Project	Land east of Westgate, Aldingbourne		
Drawing	Sketch Layout with Detailed Application Boundary - 01		
Client	Cala Homes South Home Counties		
Job no.	CALA230719	Date	31.07.23
Dwg no.	SLDAB-01	Rev.	P5
Author	AB/NN	Checked	-/-
Status		Scale	1:1000@A0
		Office	Romsey
Client ref.

WESTERGATE STREET AND MEADOW WAY, WESTERGATE, WEST SUSSEX

Stage Road Safety Audit - Designers Response

**Westergate Street and Meadow Way, Westergate, West Sussex
Proposed Site Access Arrangements
Stage 1 Road Safety Audit**

PROJECT: SITE ACCESS GENERAL ARRANGEMENT

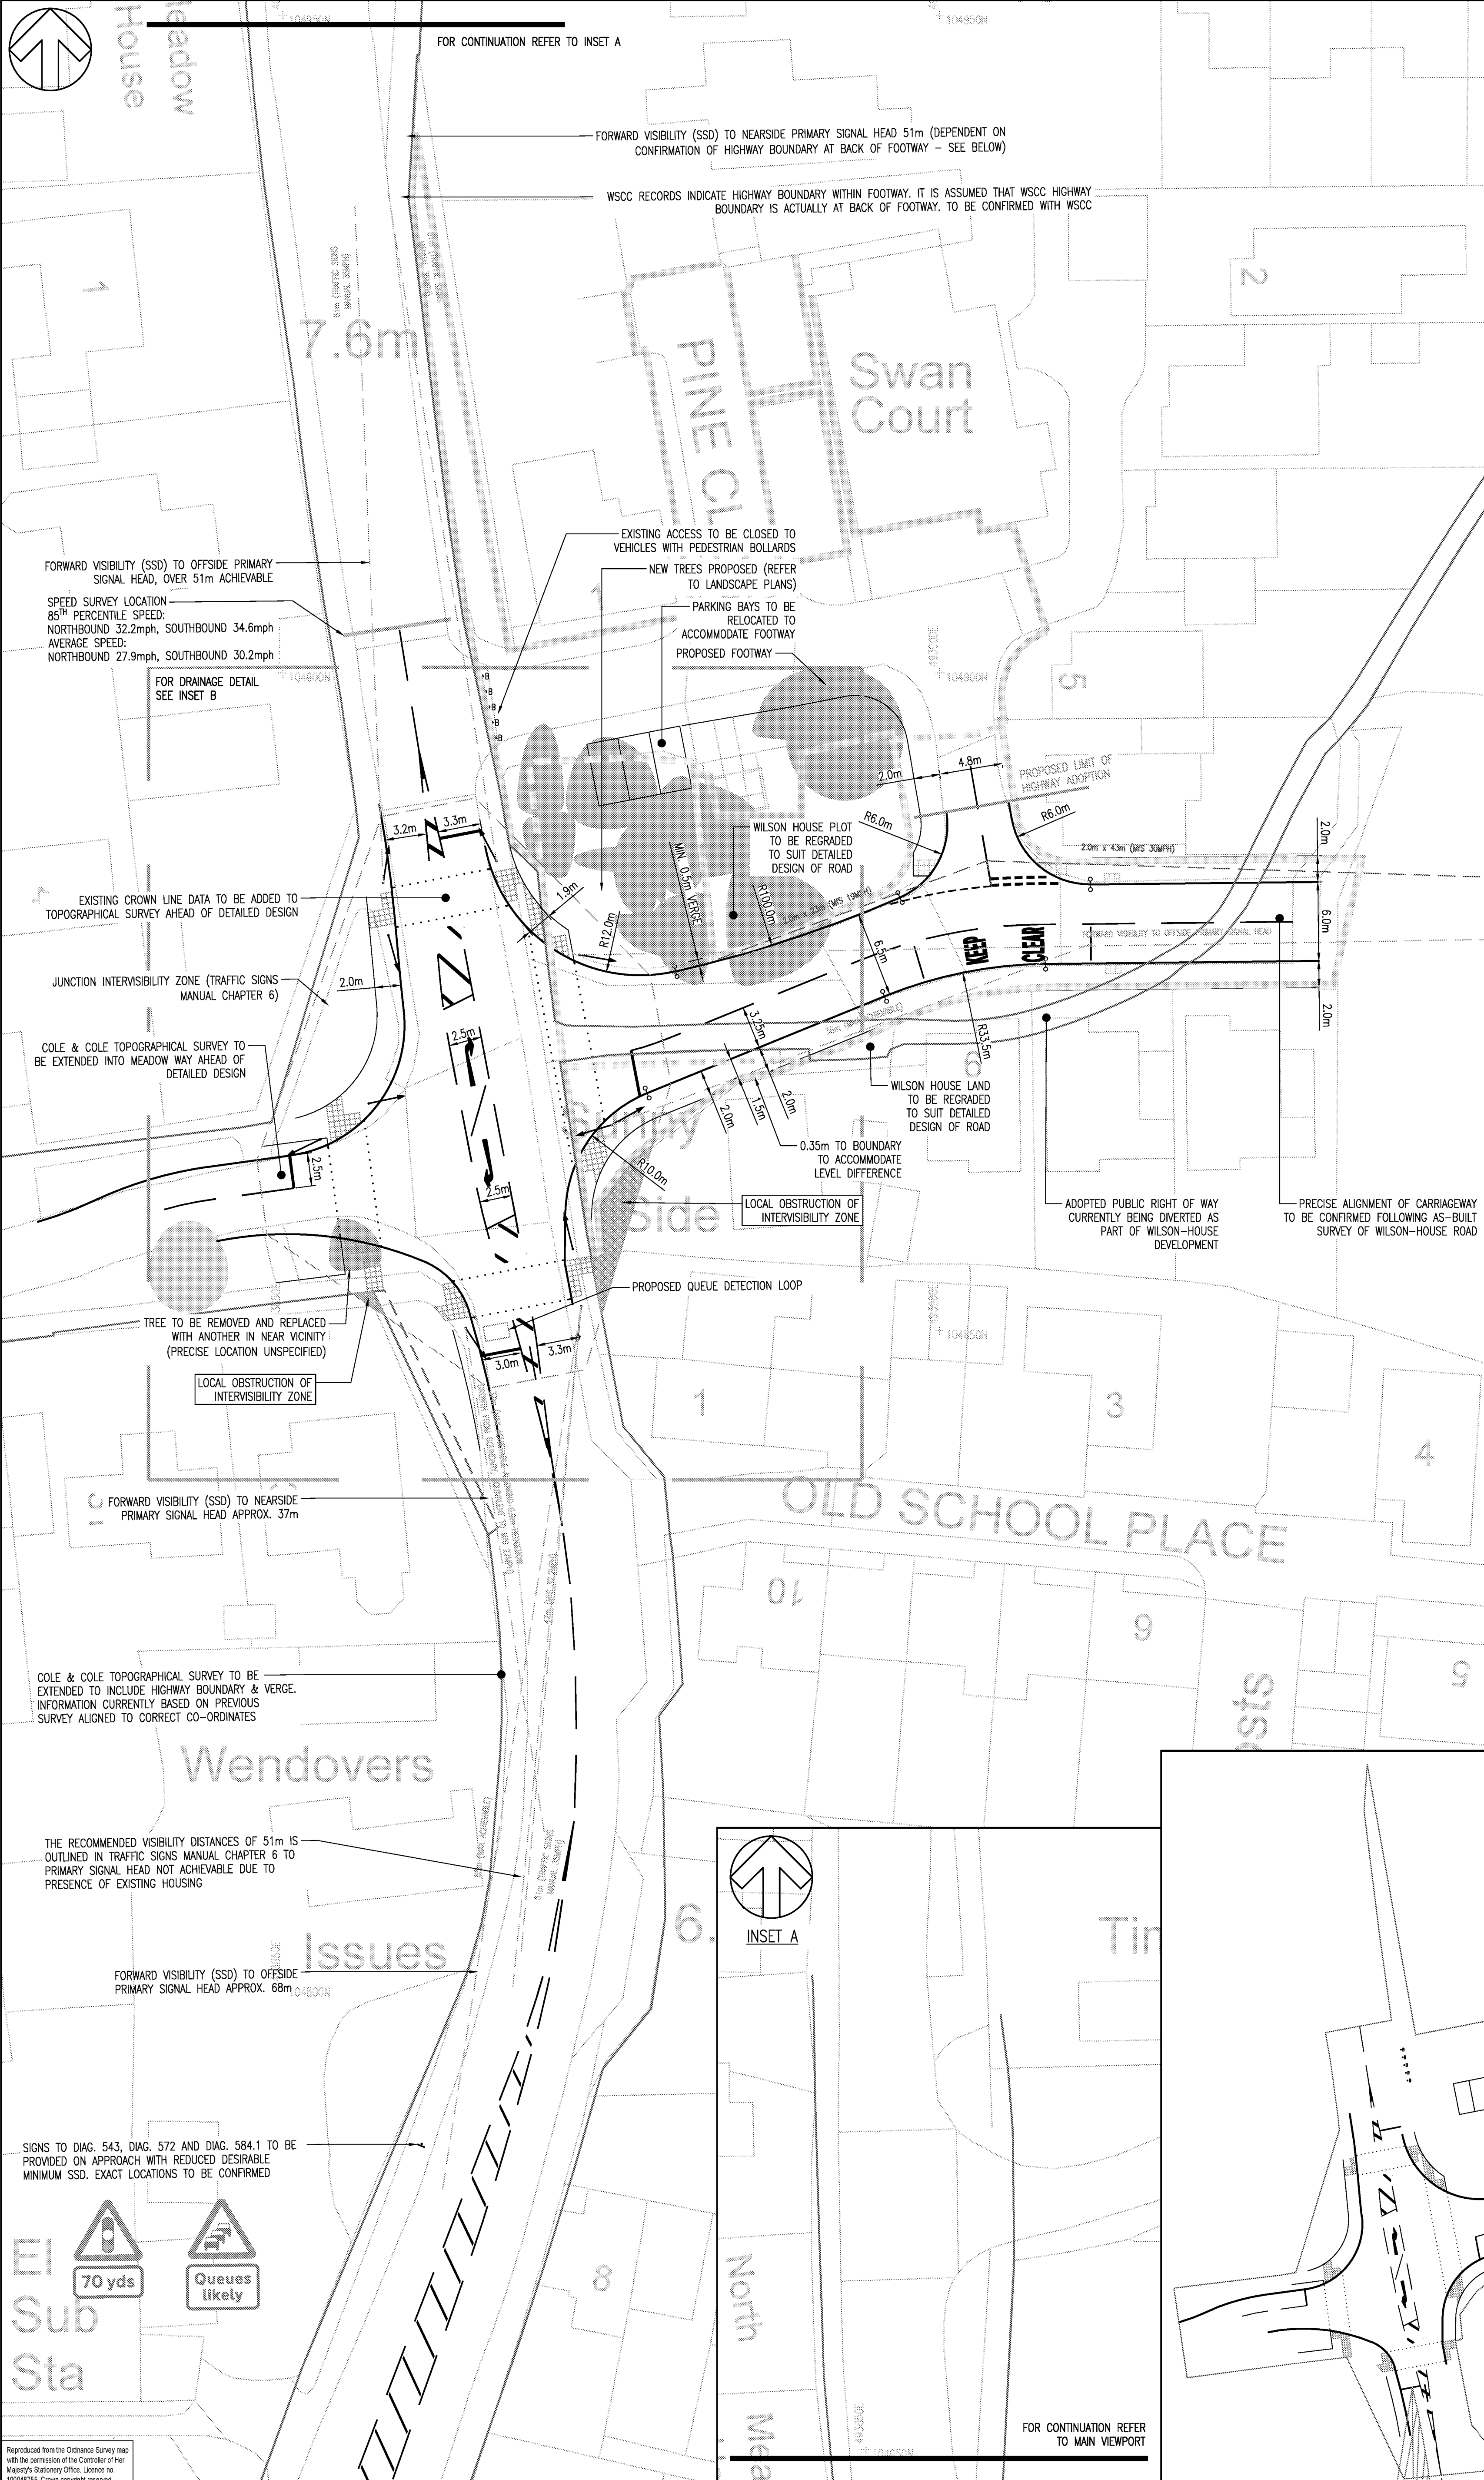
Locations 1 & 2 - On the south eastern and north western corners of the proposed traffic signal junction (Drawing No. 3258/GA/004 Rev F).

Summary - An identified Departure from Design Standard with regard to junction intervisibility could lead to a potential increased risk of side impact vehicular collisions occurring or nose to tail shunt type collisions occurring, whereby vehicle occupants could sustain personal injury.

Detail - The scheme proposals include the provision of a new traffic signal junction. The Stage 1 Road Safety Audit brief document advises of a Departure from Design Standard regarding intervisibility between the junction stop line on A29 southern arm and, the Meadow Way and site access arms of the proposed traffic signal junction. The obstructions to intervisibility are caused by the presence of existing residential boundary fences and hedges and a telecommunications mast and associated large cabinets as indicated at Location 1 and 2.

Location 3 - On the north bound approach to the proposed traffic signal junction (Drawing No. 3258/GA/004 Rev F).

The achievable forward visibility is limited by the left hand bend on the approach to the junction. Forward visibility to the nearside primary signal is 37m, equivalent to an approach speed of 27mph, and thus, the Traffic Signs Manual recommended visibility distance of 51m is not achievable.

Location 4 - On the north bound approach to the proposed traffic signal junction (Drawing No. 3258/GA/004 Rev F).

Location 5 - On the south bound approach to the proposed traffic signal junction (Drawing No. 3258/GA/004 Rev F).

Location 8 - The proposed traffic signal junction (Drawing No. 3258/GA/004 Rev F).

Detail - The scheme proposals include the provision of a new traffic signal junction at Westergate Street and Meadow Way. The scheme proposals do not appear to include the provision of a traffic signal maintenance engineer's layby or hardstanding area adjacent to the proposed traffic signal controlled junction.

- 2.2.4. Problem accepted, noting that a ‘Keep Clear’ box markings have been included on the westbound approach. This is shown on the updated Site Access General Arrangement Drawing LAW-WSP-ZZ-ZZ-C-DR-0006.
- 2.2.5. Recommendations related to the provision of an all-red detector and use of MOVA detection are also accepted and will form part of the detailed design process for the junction.

- 2.2.10. Recommendations regarding signage is accepted. The provision of signs 543 and 584 are included as part of the proposed site access junction. This is shown on Drawing XXXXXXXX.
- 2.2.11. Recommendations regarding provision of an offside primary signal head is also accepted as shown on Site Access General Arrangement Drawing LAW-WSP-ZZ-ZZ-C-DR-0006.
- 2.2.12. Recommendations regarding the use of high coloured surfacing and traffic signal operation are also accepted and will be considered further during detailed design.

- 2.2.17. Recommendations regarding signage is accepted. The provision of signs 543 and 584 are included as part of the proposed site access junction. This is shown on Drawing XXXXXXXX.
- 2.2.18. Recommendations regarding provision of an offside primary signal head is also accepted as shown on Site Access General Arrangement Drawing LAW-WSP-ZZ-ZZ-C-DR-0006.
- 2.2.19. Recommendations regarding the use of high coloured surfacing and traffic signal operation are also accepted and will be considered further during detailed design.

- 2.2.25. Recommendation accepted. The provision of high skid resistant surface course material will be considered during detailed design.

- 2.3.4. WSP has reviewed the recommendation and concluded that it was not possible to identify a suitable location where a layby could be provided on the A29 for traffic signal maintenance. However, it is noted that on-street parking will be available within the northern section of Pine Close and on Meadow Way. Given the infrequent nature of traffic signal maintenance, the use of Pine Close and Meadow Way it is considered that this will not generate a road safety issue.
